**MANCHESTER-BOSTON REGIONAL AIRPORT  
GREEN DRIVE CARGO FACILITY APRON AND ACCESS ROAD**

**ADDENDUM NO. 2**

DATE: March 23, 2022  
TO: ALL BIDDERS  
FROM: McFarland-Johnson, Inc.  
53 Regional Drive  
Concord, NH 03301  
PROJECT: Manchester-Boston Regional Airport  
Manchester, New Hampshire  
Green Drive Cargo Facility Apron and Access Road

**LIGHT ILLUMINATION AND GEOMETRY LAYOUT  
WITH APPROXIMATE BOUNDARIES AND FIXTURE AIMING**

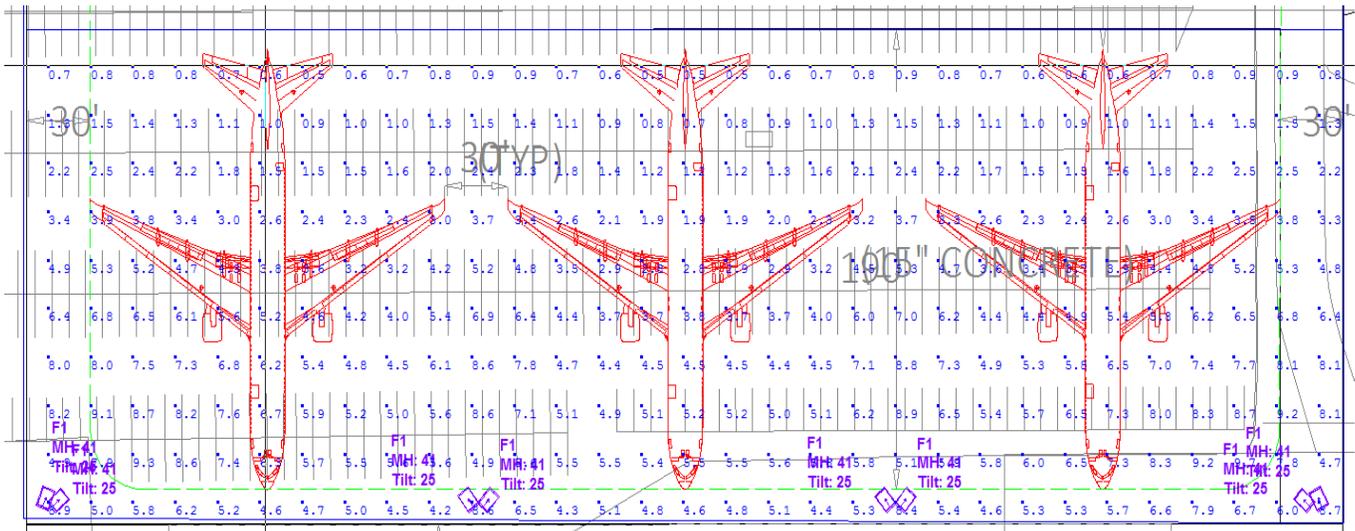
*A few questions concerning the lighting layout for the Cargo Apron.*

- 1. What light loss factors were used in the design?*
- 2. What are the boundaries of the area that the 4 poles are intended to provide light?*
- 3. What light levels and uniformity are needed?*
- 4. What wind speed is required for the pole/fixture assembly?*

**Question 1 Response:** The light loss factor using the Basis of Design fixture and pole information identified in Section M-400 specification uses a 0.9 lighting loss factor.

**Question 2 Response:** The following figure was used to determine the apron mast light pole location layout using the Basis of Design fixture and pole information outlined in Technical Specification Section M-400 Non-Airfield Electrical Improvements under paragraphs 400-2.20 Mast Light and 400-2.21 Mast Light Pole. This illumination and geometry layout also indicates the approximate lighting area boundaries and lighting levels.

**Question 3 Response:** From the above figure used for the Basis of Design, the average apron lighting levels are approximately 4 – 5 foot-candles and average/minimum ratio under 10.

**Question 4 Response:** The wind speed used for the pole/fixture assembly is minimum 100 miles/hour.
